## Exhibit B

### Recommended Amendments to the 2018 International Residential Code City of Amarillo, Texas

**\*\*\*Figure R602.6.1; delete the figure and insert the following figure:**

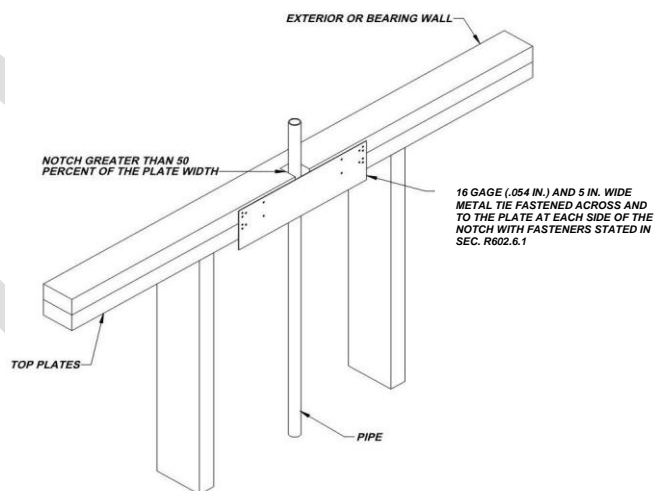
**\*\*\*Section R602.6.1; amend the following:**

**R602.6.1 Drilling and notching of top plate.** When piping or ductwork is placed in or partly in an exterior wall or interior load-bearing wall, necessitating cutting, drilling or notching of the top plate by more than 50 percent of its width, a galvanized metal tie not less than 0.054 inch thick (1.37 mm) (16 Ga) and 4-½ inches (38 mm) 5 inches (127 mm) wide shall be fastened across and to the plate at each side of the opening with not less than eight 10d (0.148 inch diameter) nails having a minimum length of 1½ inches (38 mm) or eight (#10) wood screws having a minimum length of not less than 1½ inch (38 mm) at each side or equivalent as approved by the Code Official. Fasteners will be offset to prevent splitting of the top plate material. The metal tie must extend a minimum of 6 inches past the opening. See figure R602.6.1. {Remainder unchanged}

*(Reason: To clarify proper method to utilize when notching of top plate occurs.)*

*(Reason: Amendment to provide additional assurance of maintaining the integrity of the framing by spreading the nailing/screw pattern.)*
